MEETING SUMMARY
BRUNSWICK HYDROELECTRIC PROJECT

FERC NO. 2284

DOWNSTREAM FISH PASSAGE ALTERNATIVES MEETING

January 27, 2026

Alternative D2 - Inclined Bar Rack with New Downstream Bypass Structures

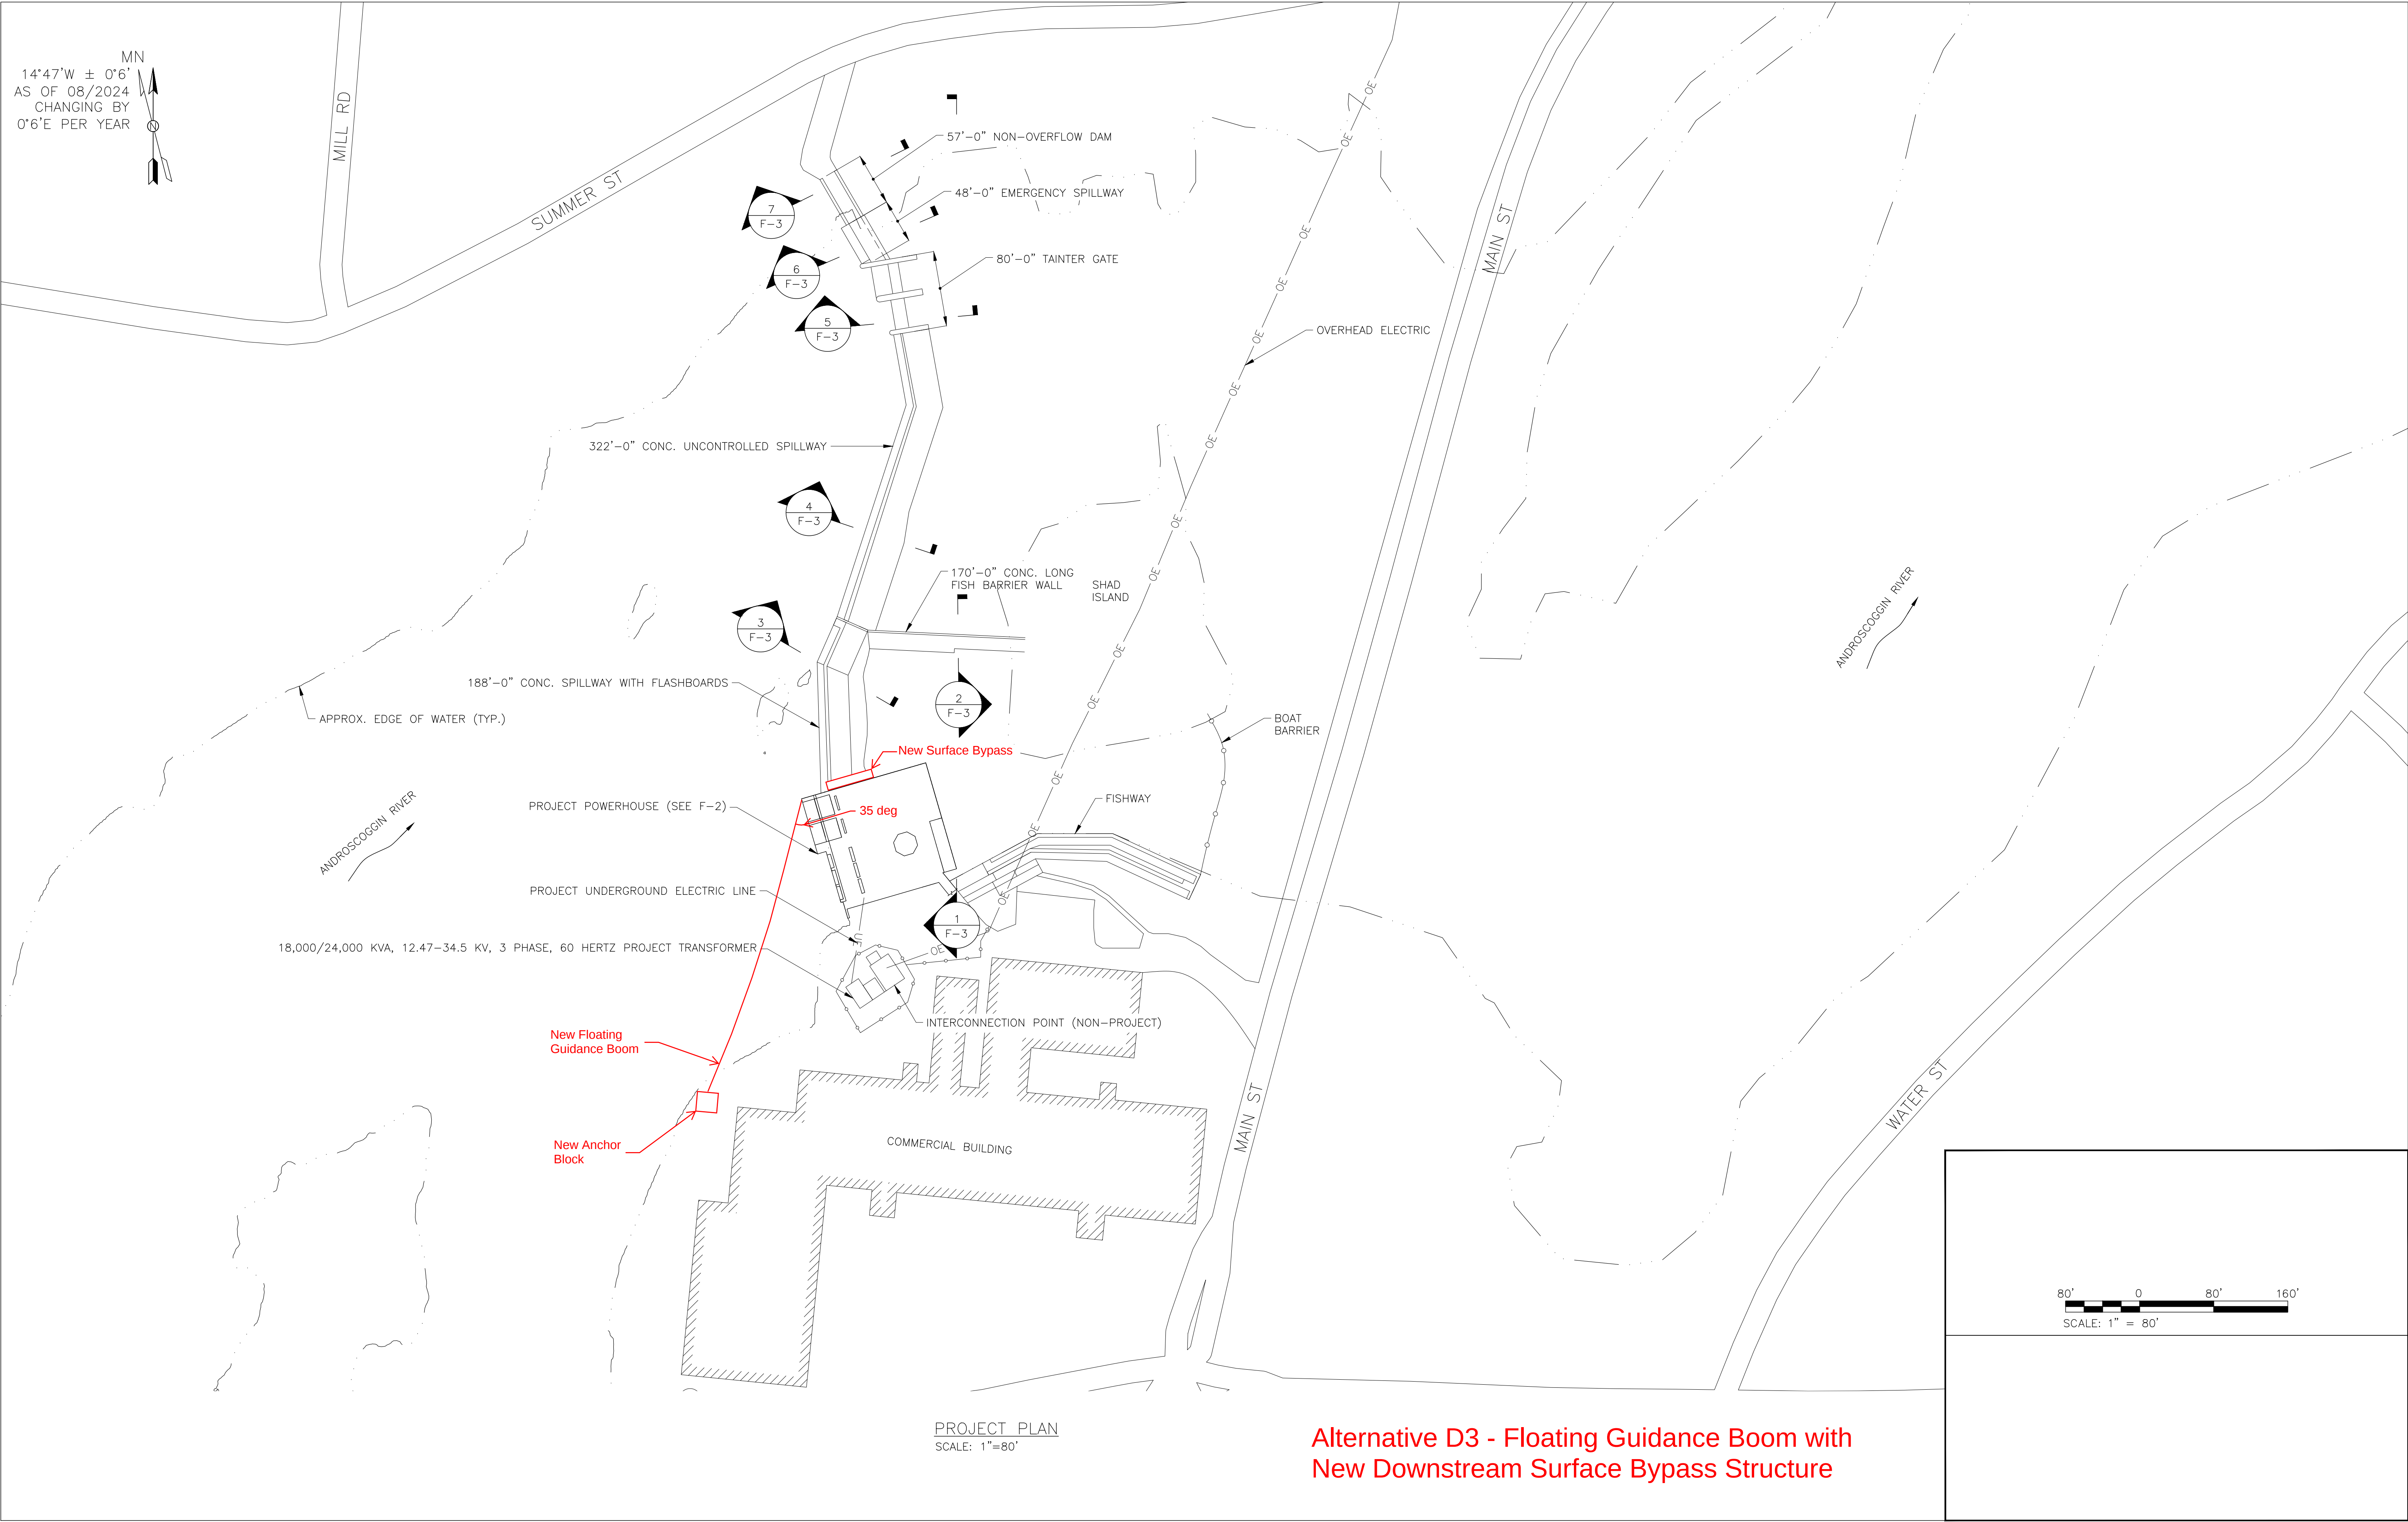
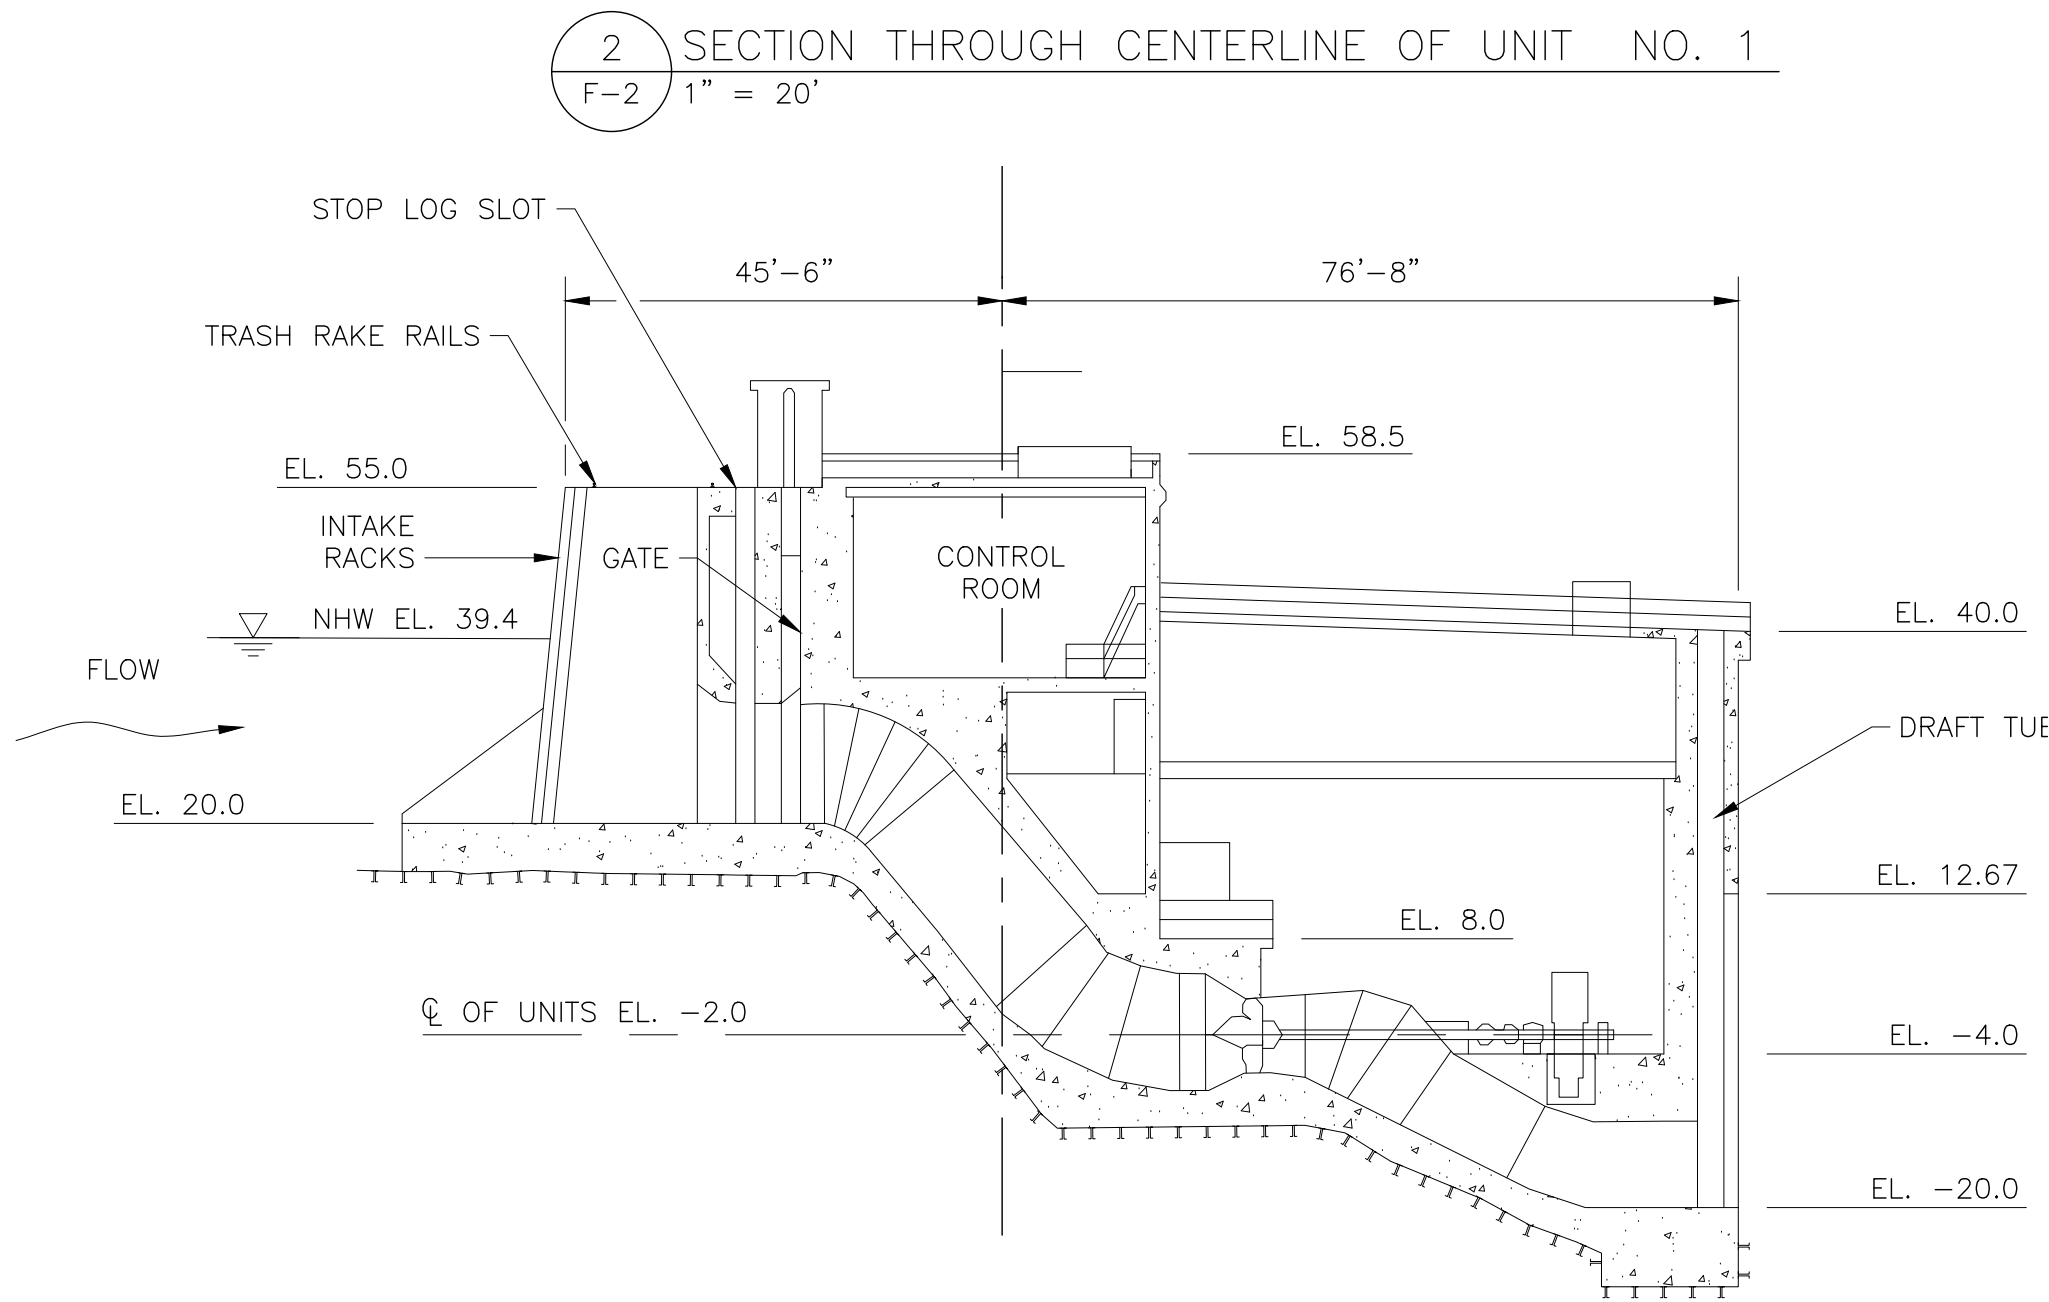
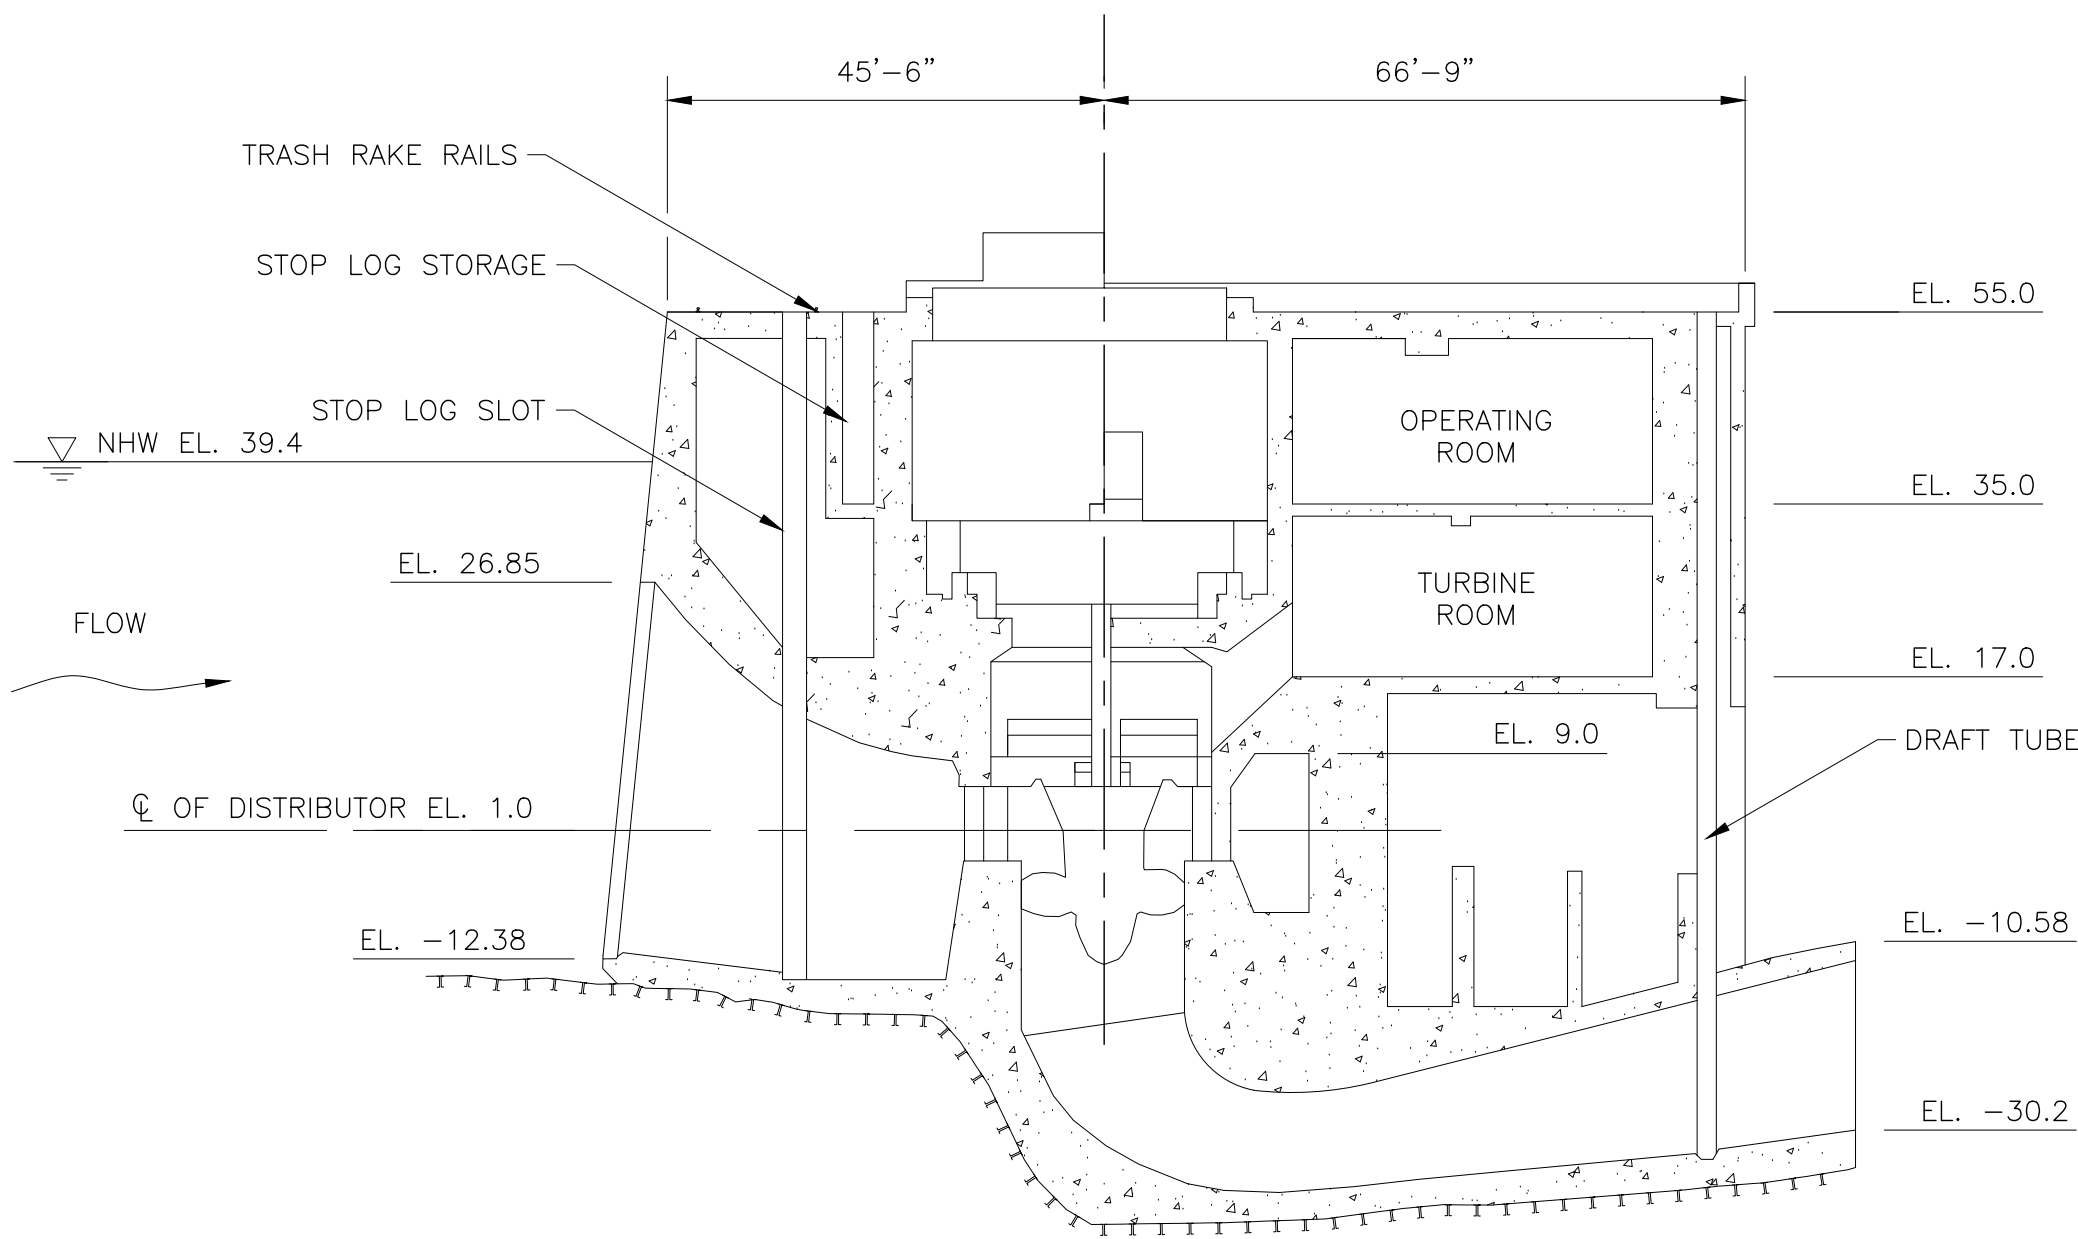
Casey Clark asked about the potential downstream bypass location and how that would be routed. Lucas replied that this alternative considered a bypass structure located just north of the powerhouse with a surface gate and then a low-level inlet. Lucas said it would be preferable to integrate the bypass into the rack face structure, but the layout of the intake did not lend itself to this type of solution. Casey Clark also asked about the infrastructure on river right (i.e., upstream fishway) and whether the river right training wall on the shore side of Unit 1 could be moved any further to the right to address potential velocity issues to prevent fish from being falsely attracted to the area. Lucas replied that the current layout tries to minimize impacts to upstream fishway, and a modification like moving a training wall could present design challenges if the upstream fish passage remains on river right.

Vladimir Douhovnikoff asked if it would make sense to examine the 1/2-inch rack spacing with this alternative. Lucas replied that the CFD modeling would not be able to assess changes in rack spacing from 3/4-inch to 1/2-inch. Vladimir Douhovnikoff stated that it may be helpful to know if closer spacing could be effective, and what the impact would be on generation. Kirk Smith stated that the selection of 3/4-inch clear spacing was being driven by the USFWS engineering guidelines, which reflects the protective spacing for American eel, and that examining closer spacing would begin to have significant impacts on generation likely making the alternative unfeasible relative to other options. Matt Buhyoff stated the results of the alternatives analysis will be filed with FERC, who will be developing their own license recommendations, and it would be premature to dismiss closer-spaced rack alternatives from the analysis, and their technical feasibility should be investigated. Mike Scarzello stated that Brookfield is following USFWS engineering guidelines with the 3/4-inch clear spacing described in the alternatives.
